Reply to Office Action of September 16, 2005

REMARKS

ANNOTATED SHEETS SHOWING CHANGES

FIG. 1
(PRIOR ART)

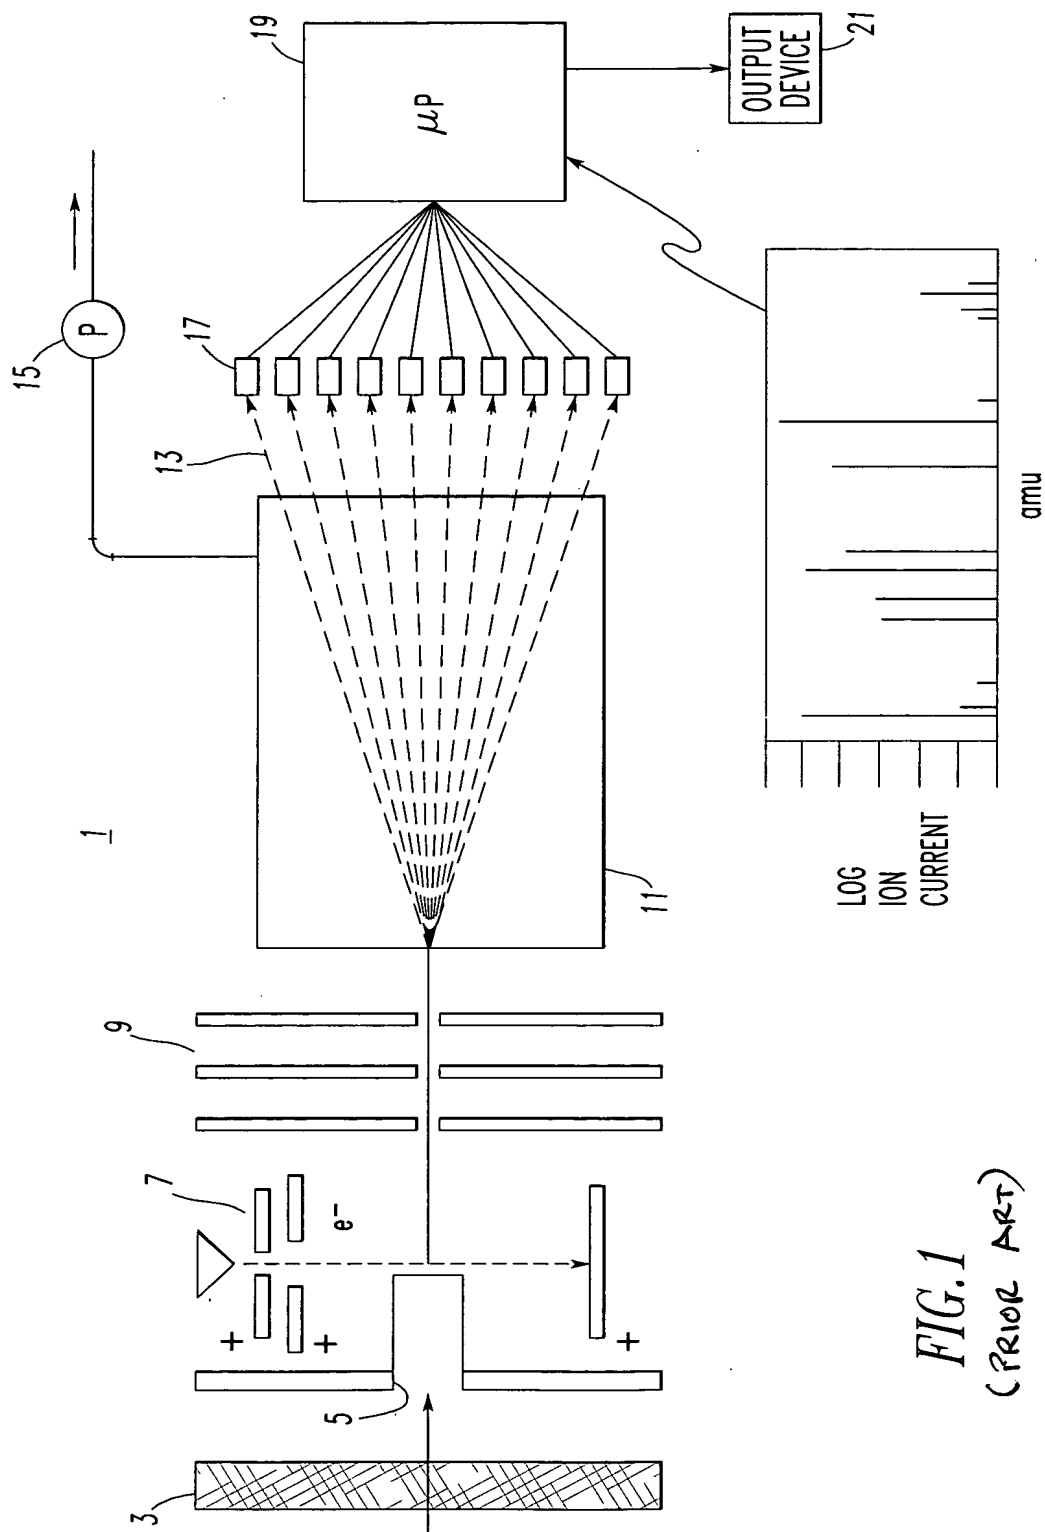
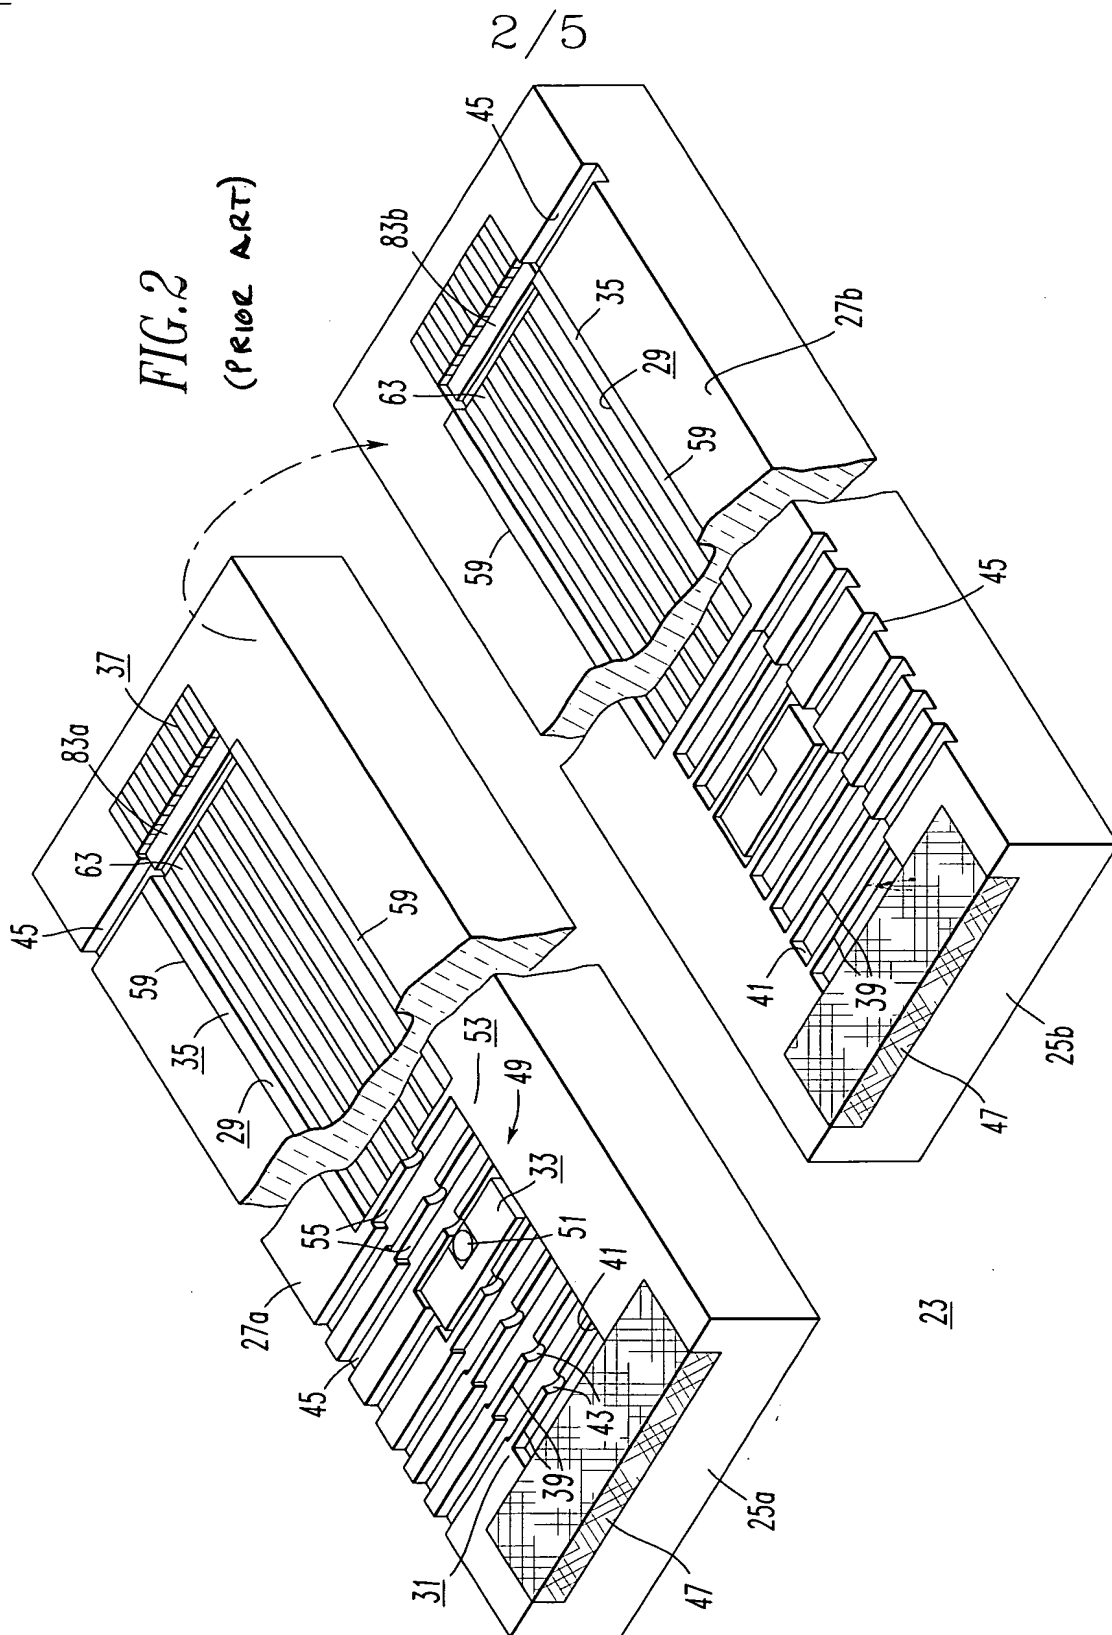
In the detailed action, the drawings were noted to require correction with respect to Figures 1, 2 and 3 so as to include the legend "Prior Art". In this response, Figures 1, 2, 3 and 4 now include the legend "Prior Art". These changes appear on new replacement sheets filed herewith. Additionally, Figures 5(a) – Figure 8 are being amended so as to more fully disclose the invention, along with replacement of reference numerals corresponding to amendments being made to the specification by this response.
